Access Compliance Report

Public Rights-of-Way

(Curb Ramps)

Intersection ID: 44025	Main Street: EASTWAY_DR	Cross Street: EASTWAY_DR_RA	Location: NE
ADA ID: 0F03399B663B	Ramp Type: Perp	Initial Pass/Fail: Fail	Overall Compliance: No
Severity Score: 33.75			
Codes/Mitigation Info/Possible Solution		Field Measurements/Component Compliance

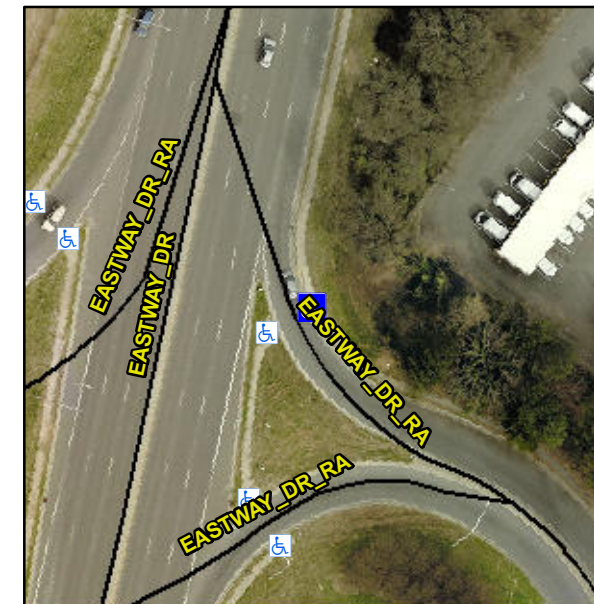
Not Found, R304.5.1, R304.2.2, R304.5.3

Compliance	Description	Data	Compliance	Description	Data
N/A	Ramp Length (in)	74.5	No	Ramp Slope (%)	8.5
No	Ramp Width (in)	46.0	No	Ramp XSlope (%)	5.1
N/A	Flare Type LT	N/A	N/A	Flare Type RT	N/A
N/A	Flare Slope LT (%)	N/A	N/A	Flare Slope RT (%)	N/A
N/A	Flare Traversable LT?	N/A	N/A	Flare Traversable RT?	N/A
N/A	Landing Length (in)	N/A	N/A	DWS Provided?	N/A
N/A	Landing Width (in)	N/A	N/A	DWS Contrast?	N/A
N/A	Landing Slope (%)	N/A	N/A	DWS Length (in)	N/A
N/A	Landing X Slope (%)	N/A	N/A	DWS Full Width?	N/A
N/A	Landing Curb? (Y/N)	N/A	N/A	DWS Offset (in)	N/A
N/A	Shared Landing?	N/A			
N/A	Gutter Ponding?	N/A	N/A	Gutter Slope (%)	N/A
N/A	Gutter Lip Ht (in)	N/A	N/A	Gutter X Slope (%)	N/A
N/A	Painted X Walk1?	No	N/A	Painted X Walk2?	N/A
	X Walk 1 Direction	To SW		X Walk 2 Direction	N/A
N/A	X Walk 1 Width (in)	N/A	N/A	X Walk 2 Width (in)	N/A
	X Walk 1 Slope (%)	2.6		X Walk 2 Slope (%)	N/A
	X Walk 1 X Slope (%)	5.7		X Walk 2 X Slope (%)	N/A

Remove & Replace Entire Ramp.
